CitiPower/Powercor Technical Standards Update for November 2021

EE011, EE021 and EE031 – standards update

FA, FB, FC & FM Series - Public Lighting Scheme Copper Theft Mitigation

Figure 1 – Supply Cable Description

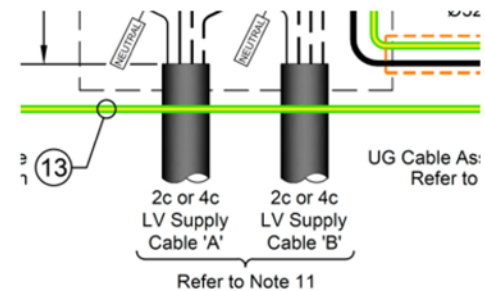
- Technical Standards FC001, FC101 and FC901-961 have been updated with details of the new 25mm² 4c aluminium public lighting cable (Figure 2).
- Technical Standards FA081, FB111, FB121, FB131, FB132, FB133, FB151 and FM011 have been updated to include details of the new 25mm² 4c aluminium public lighting cable in the connection diagrams (Figure 1).
